**Subject: Response to Portion of NRC Request for Additional
Information Letter No. 147 Related to ESBWR Design
Certification Application - Containment Systems -
RAI Number 6.2-53 S03**

**Response to Portion of NRC Request for
Additional Information Letter No. 147
Related to ESBWR Design Certification Application**

RAI Number 6.2-53 S03

DCD Markups

Figure 6H-1. Air Mass Profiles in the GDCS Airspace
(Case A: MSL3_1DPVCB_NL2Pa-72)

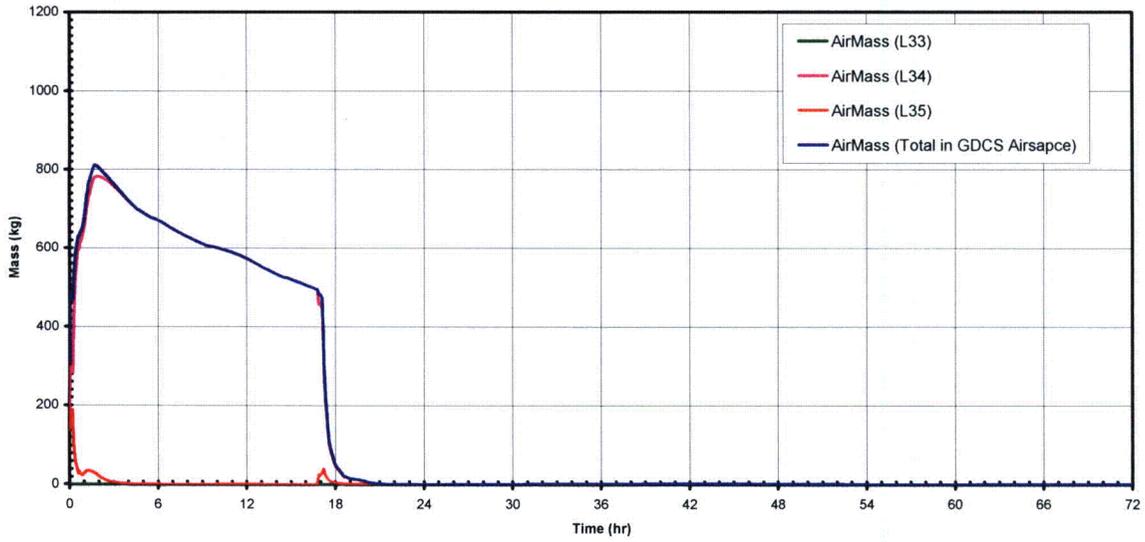
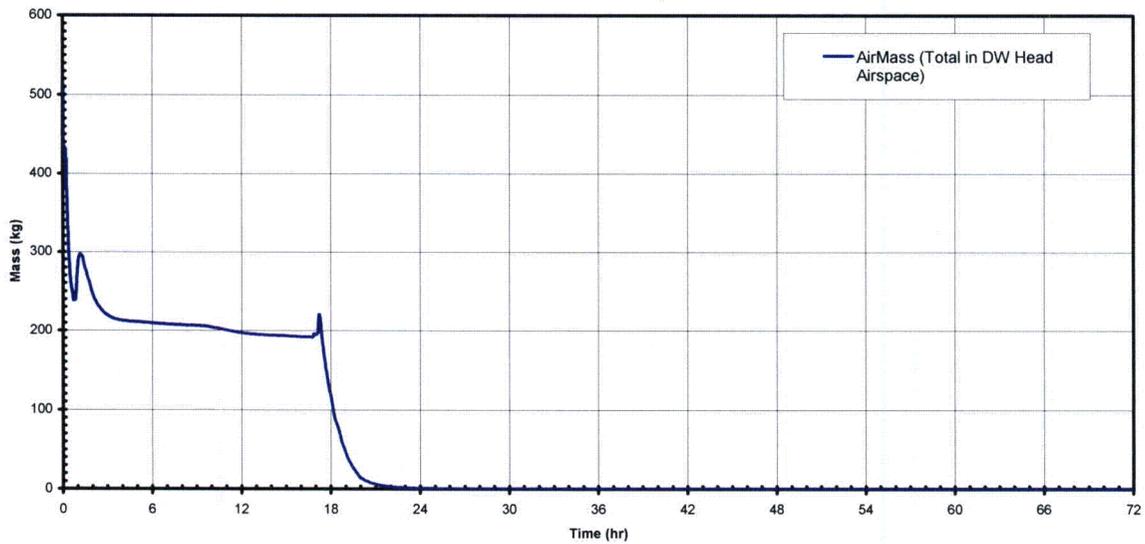
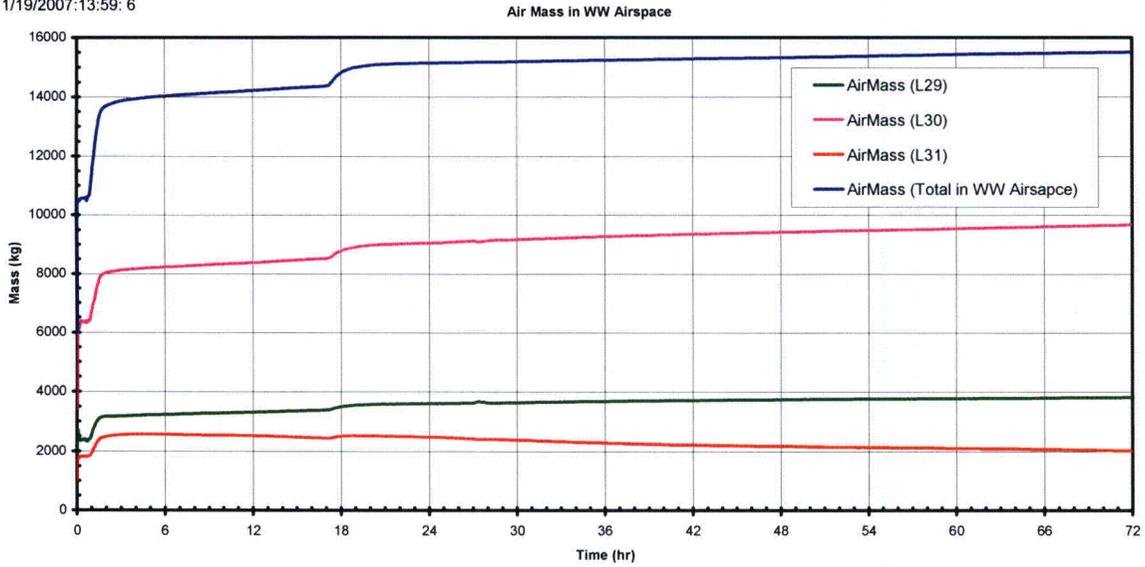
GEH response to RAI 6.2-53, Supplement No. 2, provided additional TRACG outputs (transient air mass profiles in gravity drain cooling system, drywell (DW) head, and wetwell airspaces); and parametric results (impact of various model/plant parameters on the long-term DW pressures), for the limiting main steam line break design basis accident. The staff found the response to be acceptable except that the information was not incorporated into the DCD or a topical report. To support staff's safety evaluation, include the information in either the DCD Tier 2, or in one of the related topical reports, e.g., NEDC-33083P (TRACG Application for ESBWR Transient Analysis) or NEDE-32176P (TRACG Model Description).

This section provides the additional TRACG outputs for this limiting break case, e.g., the transient air mass profiles in different regions. Figures 6H-1 to 6H-3 show the air mass profiles in the GDCS, DW head and WW airspaces. After 20 hours into the transient, all the air mass in the GDCS and DW head airspaces is essentially purged and transferred into the wetwell airspace. After that time, the air mass in the wetwell airspace continues to increase gradually due to the generation of radiolytic gases in the core during the transient.
